10/670,954

Office Action Summary	Application No. 10/670,954	Applicant(s) LUSTENBERGER ET AL.	
	Examiner Rick K. Chang	Art Unit 3726

DETAILED ACTION

Fig. 8

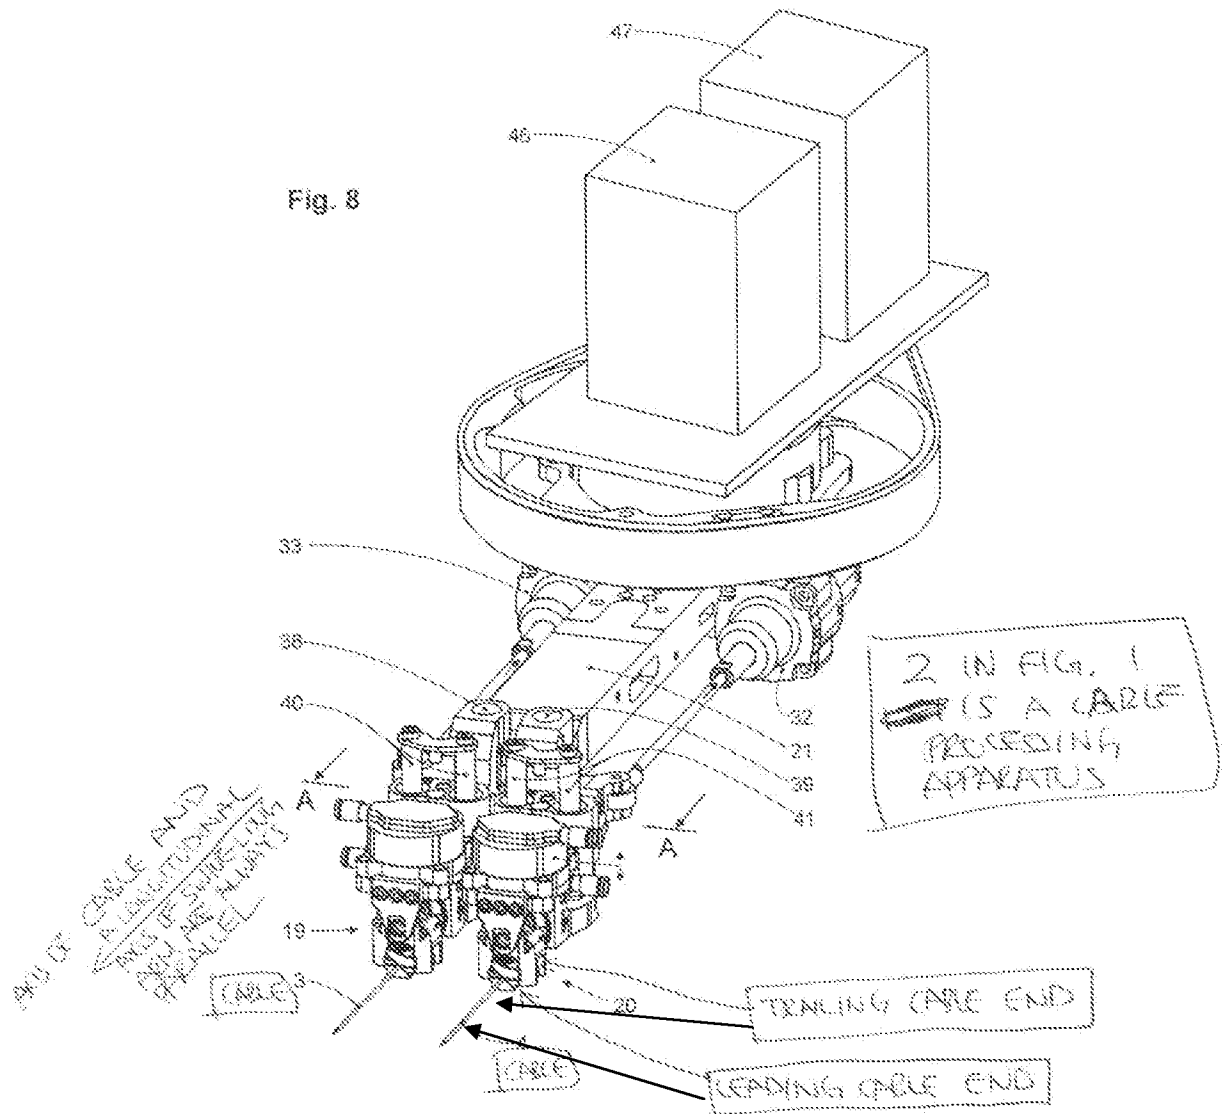
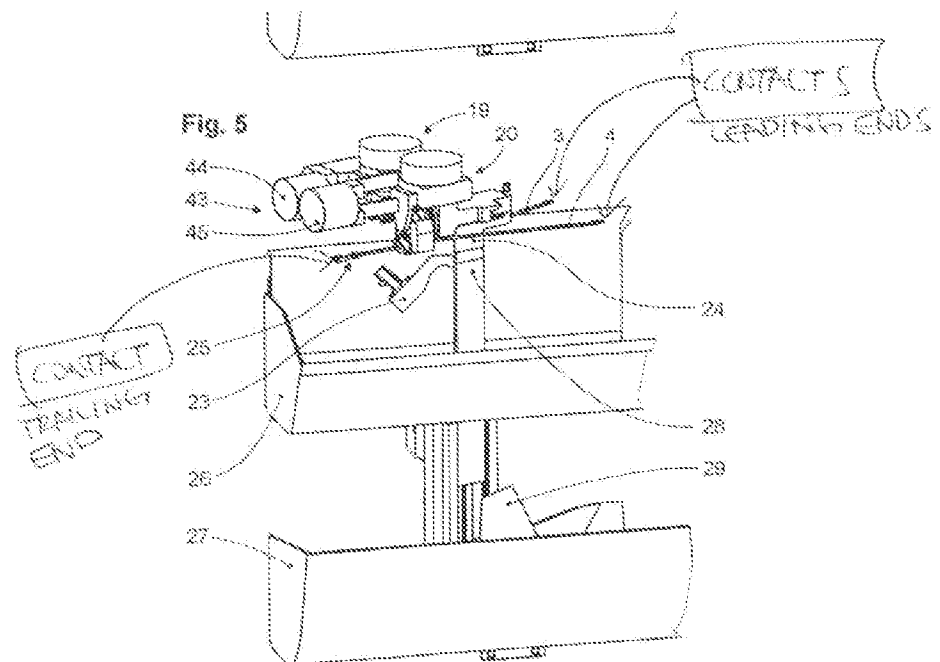
Conte discloses in Fig. 1 8-11 and 22 of different cable-end processing stations and 22 being a double crimping unit; 5-6 provide cables and belt drives; 7 is the swiveling arm and gripper; Fig. 8 shows a turntable with a belt drive below 46 and 47; 14 is a cable transportation belt; 7 being a sole means for holding and moving respectively the leading and trailing cable-ends of the cable length. 14 is a belt-drive; 26 is a cable tray; see entire cols. 2-3 for the operation of the cable deposit device.

The ends of the cables are located within the grippers of Conte. See annotated Fig. 5 above. Conte does not claim that the cables are being levitated.

The applicant's gripper and arm are incapable of being "a sole . . ." The trailing end will be located within "4" during moving the leading end. On the other hand, Conte discloses the claimed limitation.
